Moorhead Area Public Schools  
Sports Center North Rink Mechanical Upgrades  
Moorhead, MN

ZBA Project No. 25-029

Date: February 9, 2026

### ADDENDUM B

2 SECOND LEVEL FLOOR PLAN - NORTH RINK  
SCALE: 1/16" = 1'-0"

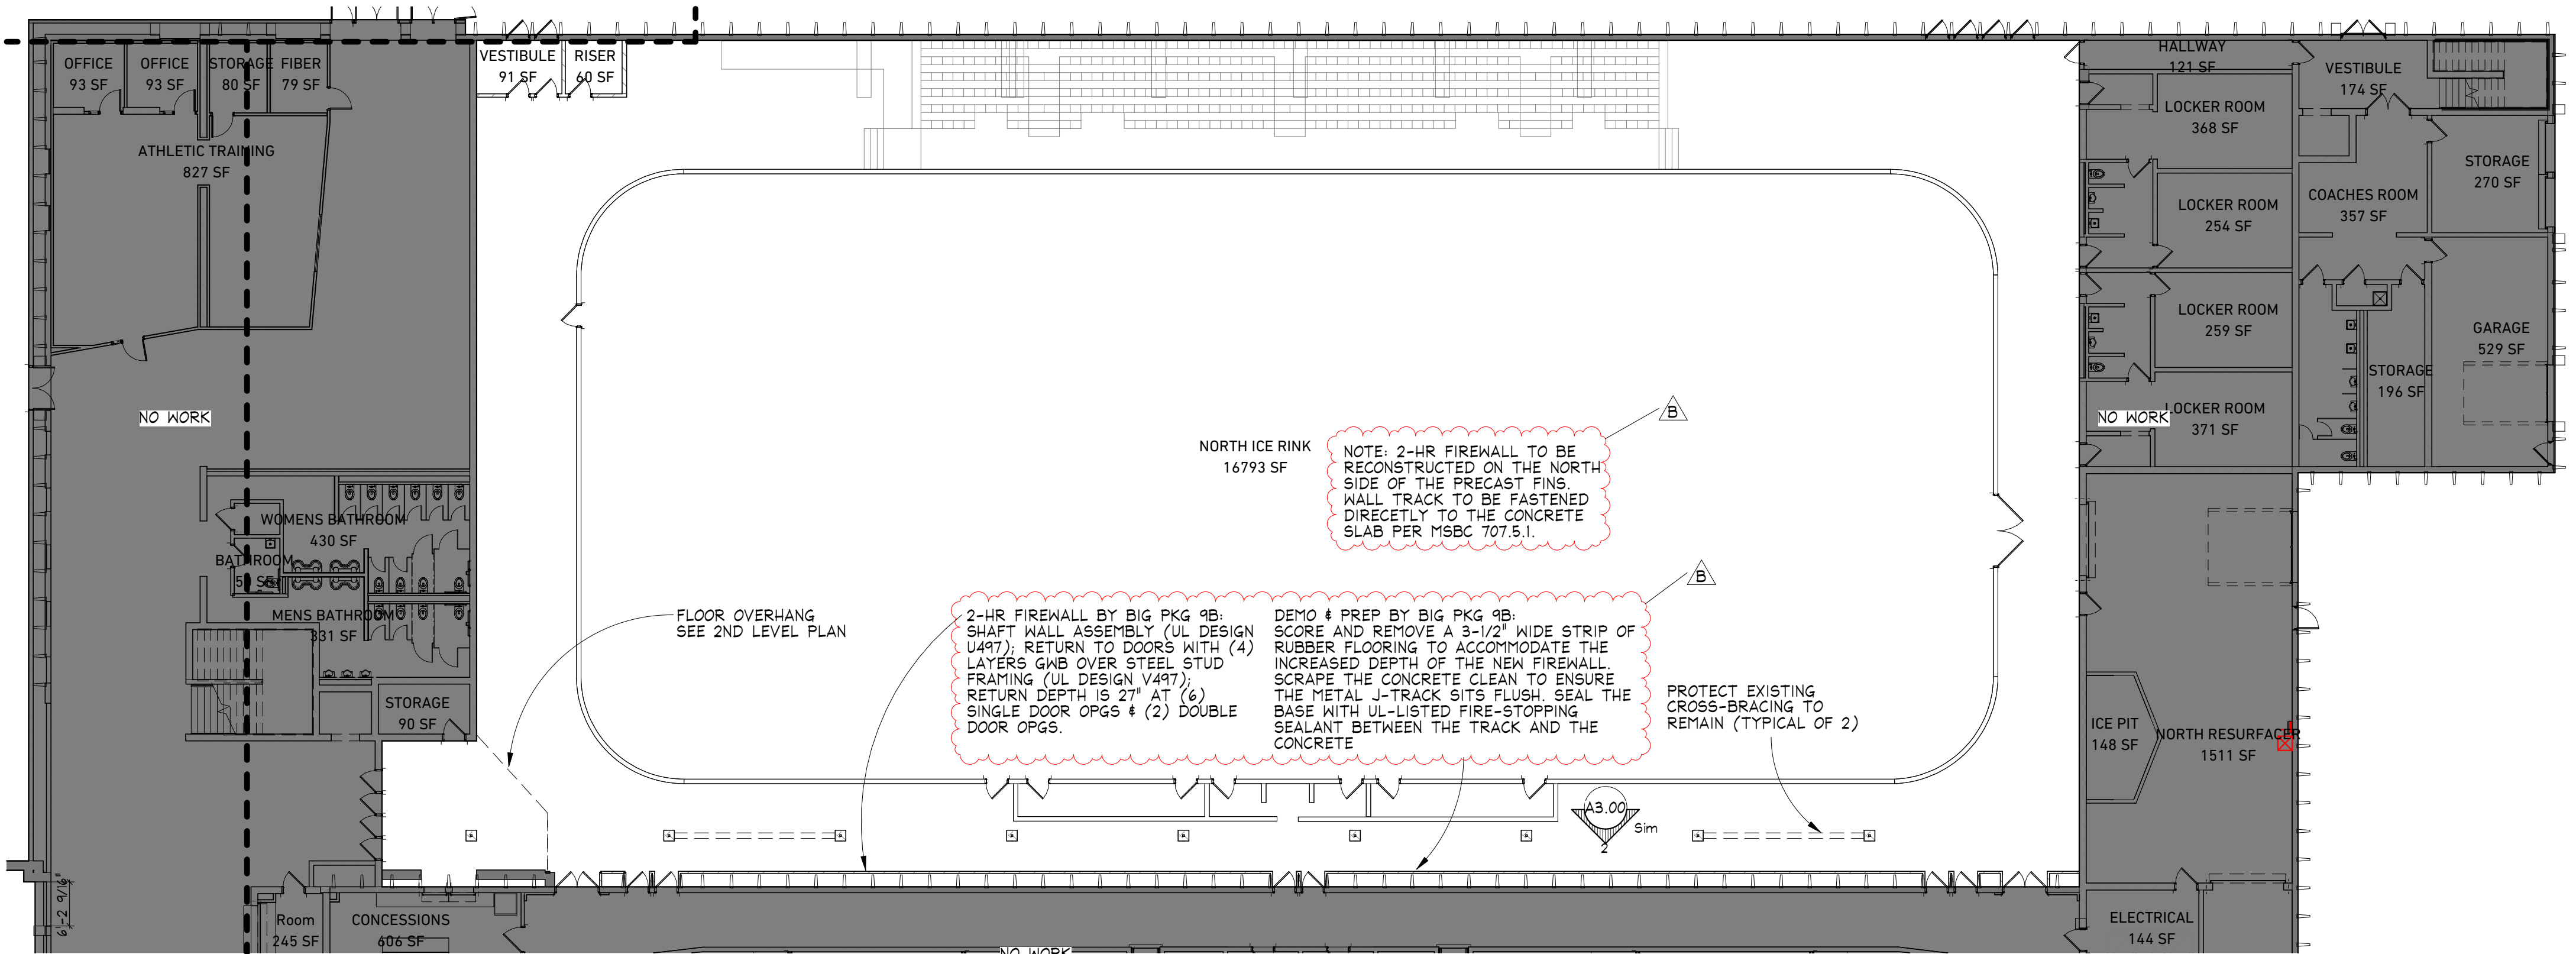
1. Main and Second Level Floor Plans 1 & 2/A3.01: Revise notes.
2. Images 1 & 2: Add demolition note.

1 FIRST FLOOR HVAC PLAN  
 M301 1/8" = 1'-0"

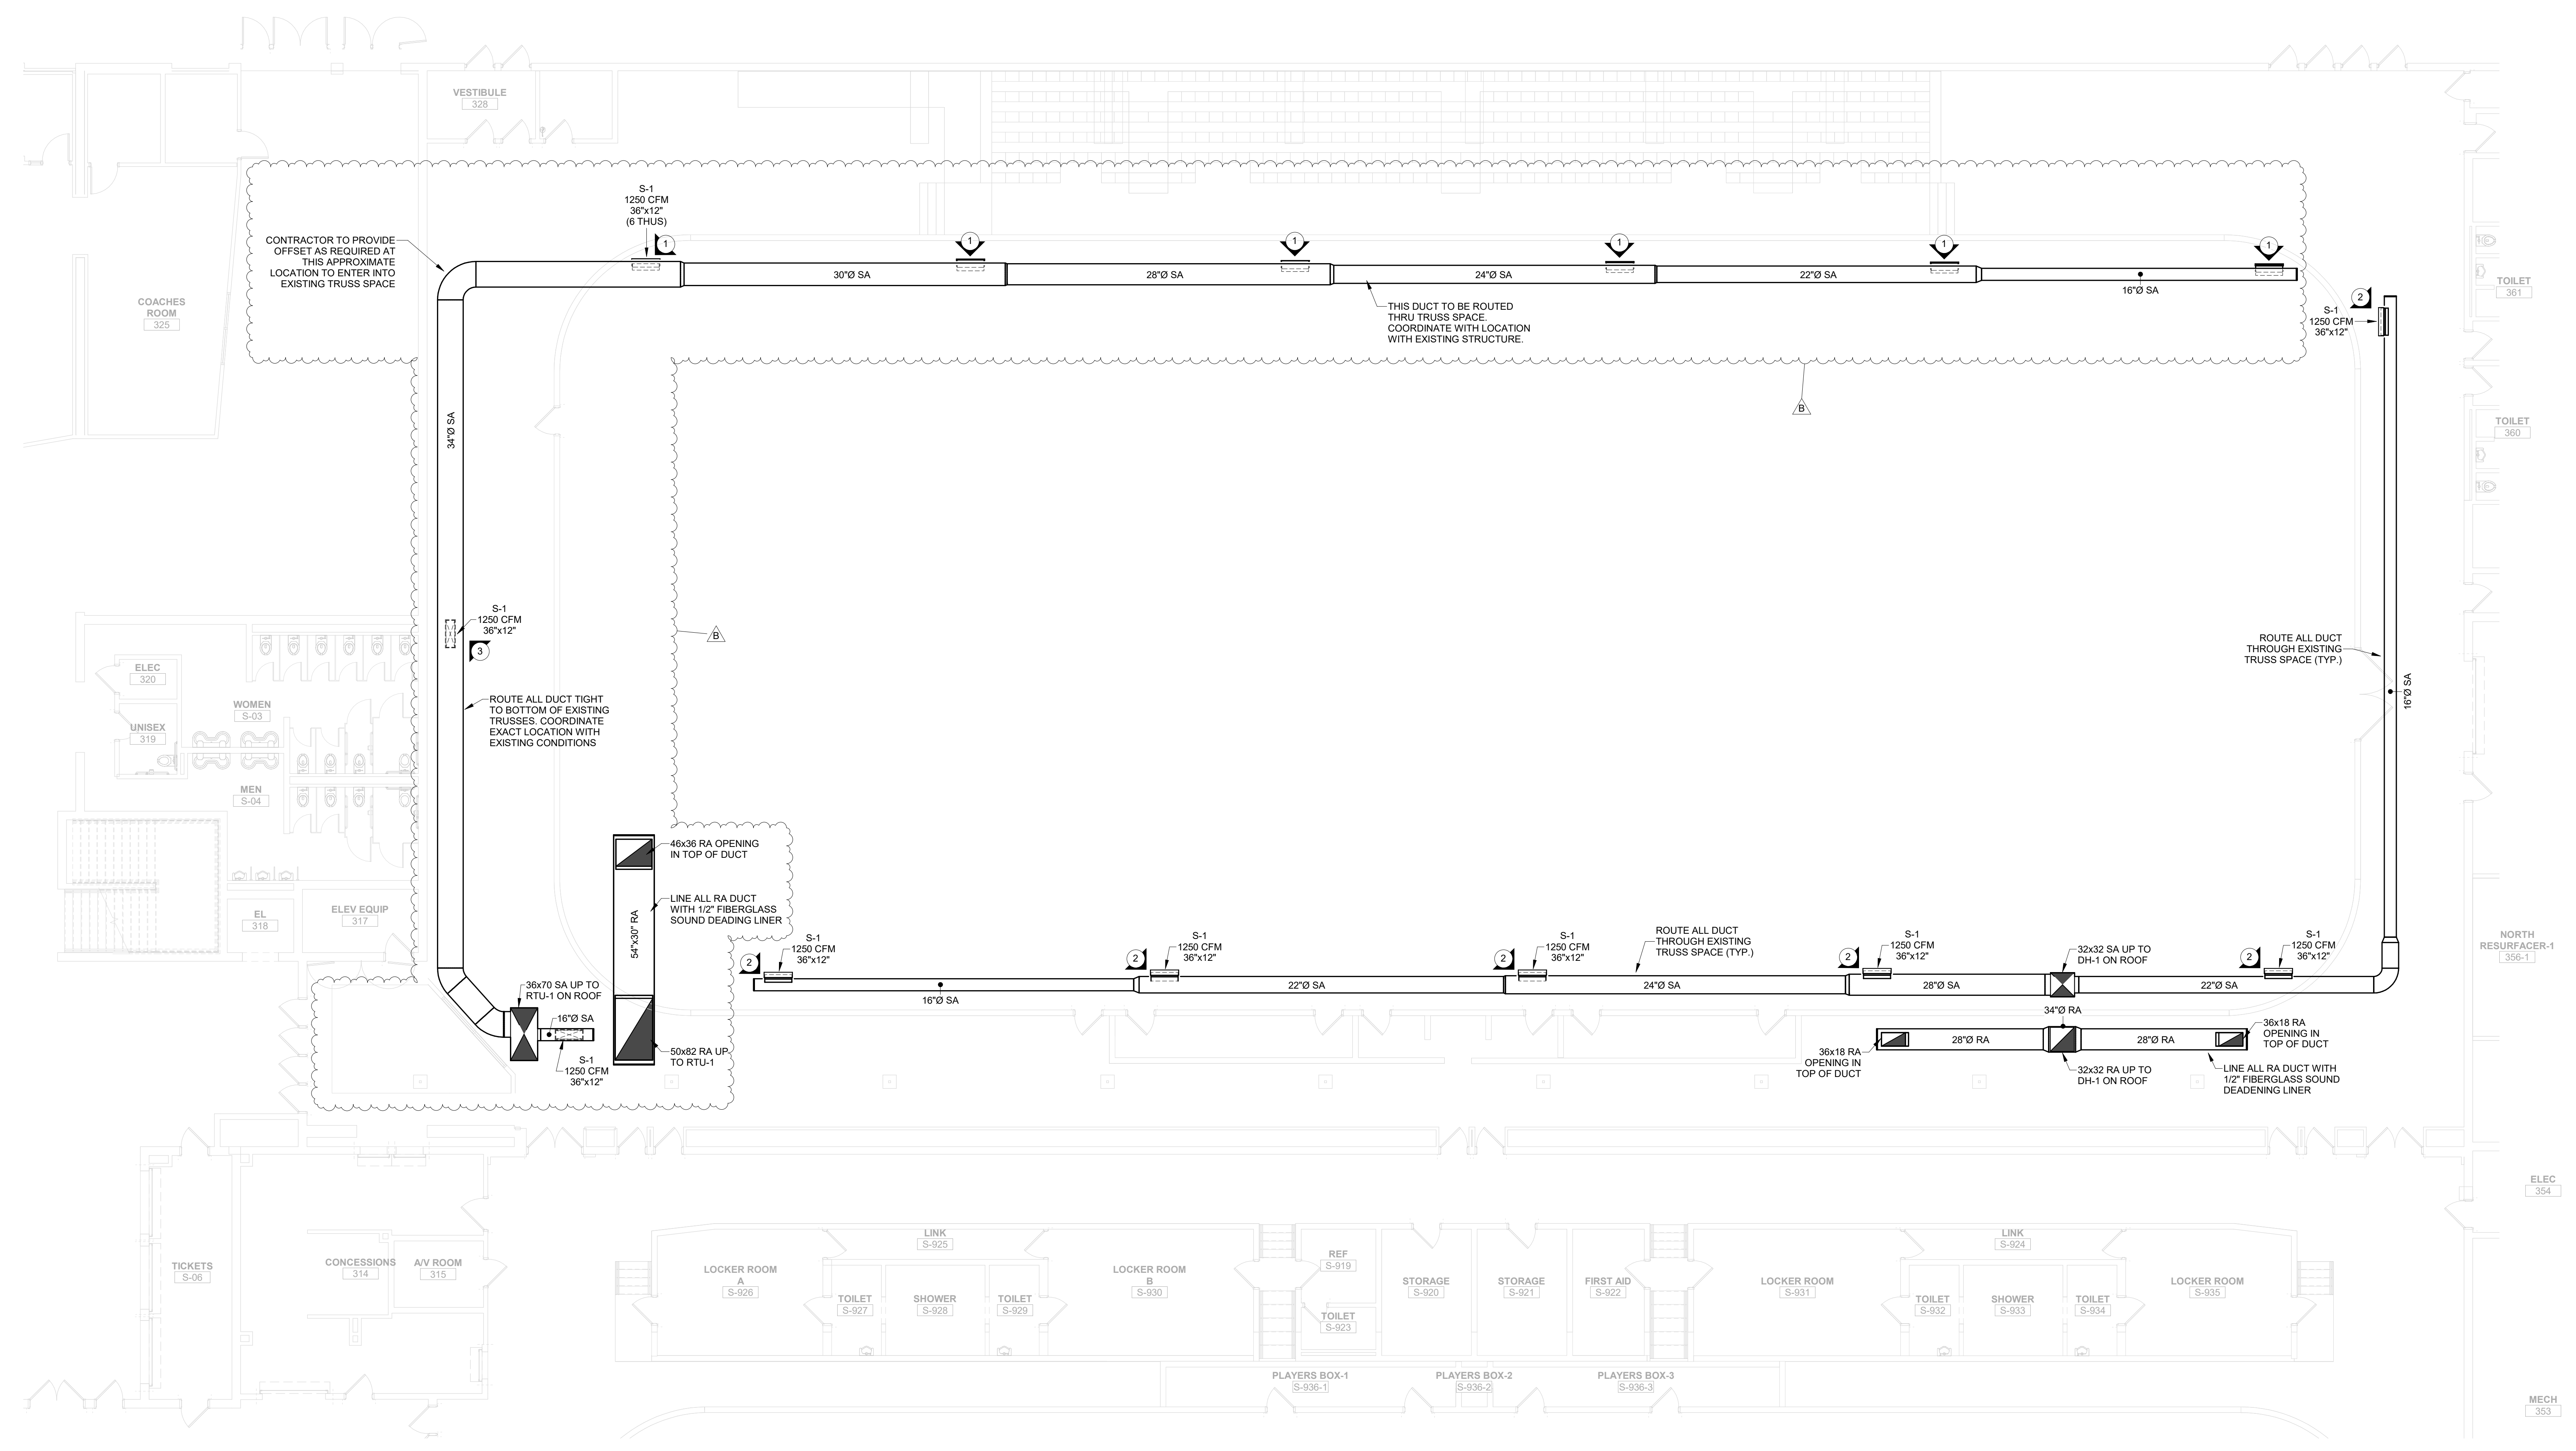
Revise RTU-1 supply duct routing as indicated to avoid conflicts with existing structure.

Provide sound liner on RTU-1 return duct as noted.
